**WICK
RNP
RWY 31**
(ACFT CAT A,B,C)

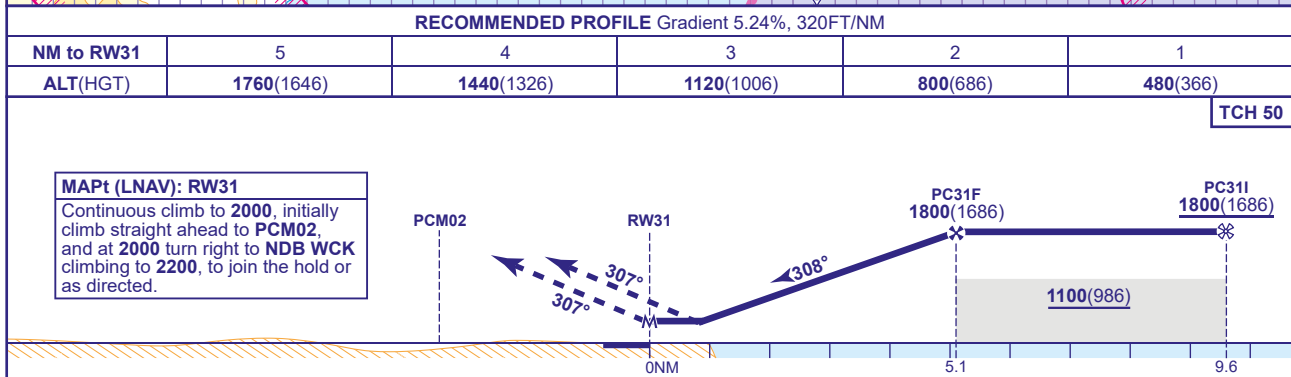
CHANGE (3/26): MAG INFO REVISED. MAG HEADINGS. PROCEDURE ALTITUDES REVISED. TAA REVISED. MISSED APPROACH REVISED.
